# UNITED STATES PATENT AND TRADEMARK OFFICE

APPLICATION NO.	FILING DATE	FIRST NAMED INVENTOR	ATTORNEY DOCKET NO.	CONFIRMATION NO.
09/961,287	09/25/2001	Tatsuo Uchida	2224-0189P	5315

<b>Office Action Summary</b>	<b>Application No.</b> 09/961,287	<b>Applicant(s)</b> UCHIDA ET AL.	
	<b>Examiner</b> Timothy L Rude	<b>Art Unit</b> 2871

**FIG. 1**

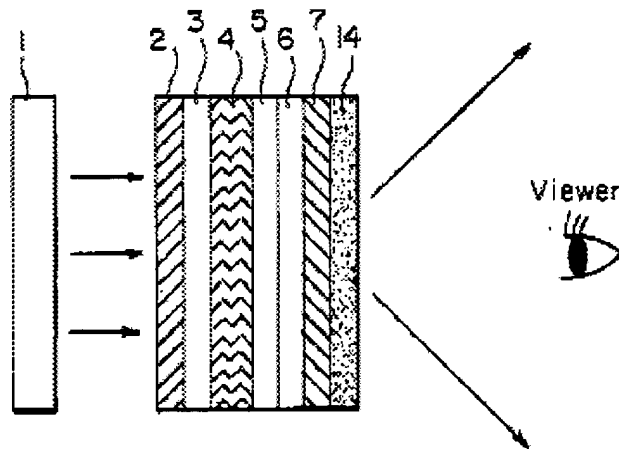
As to claim 1, Honda teaches nine examples of one embodiment of a light-scattering sheet comprising a light-scattering layer which comprises a plurality of resins (col. 3, lines 1-22) varying in refractive index (col. 3, lines 5-8) and scatters an incident light isotropically (specified haze is not anisotropic, col. 4, lines 29-65), and has a domain gap of 1 to 20  $\mu\text{m}$  providing smooth diffusion (col. 4, lines 53-55) of light (overlaps Applicant's regular phase separation structure having an average interphase distance of 3 to 15  $\mu\text{m}$ ).

The light-scattering layer of Honda has a phase separation structure composed of a plurality of resins varying in refractive index, and has a structure formed by irradiating UV light (col. 4, lines 5-8) (Applicant's spinodal decomposition, per specification page 31, lines 14-25) which would result in a bicontinuous phase structure per Applicant's enabling disclosure (Specification page 31, line 15 through page 36, line 6).

Fig. 3

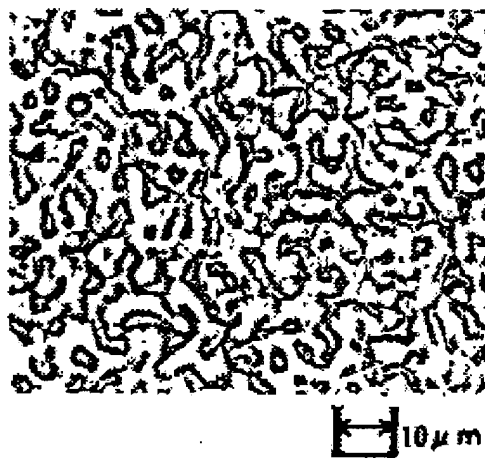
- (1) It is respectfully pointed out that Applicant's enabling disclosure (Specification page 31, line 15 through page 36, line 6) teaches a number of methods may be used to make the claimed invention, including the method disclosed by Honda. Examiner has considered Applicant's disclosure to be enabling, and therefore the method of Honda satisfies the steps of Applicant's ultraviolet polymerization method (Specification page 31, lines 18-24). Applicant has not cited any method as being a

best mode, so Examiner considers all methods to be substantially equal on their merits. Examiner was not able to find any specific steps in Applicant's method of making that are directly attributable to the formation of "regular" phase separation structure that is not taught by Honda. Furthermore, Applicant's Figure 3 indicates Applicant's structure is no more regular than one would expect from the invention of Honda. Honda contrasts his invention from the regularity of a phase lattice that is known in the art to be very regular, unlike Applicant's Figure 3.
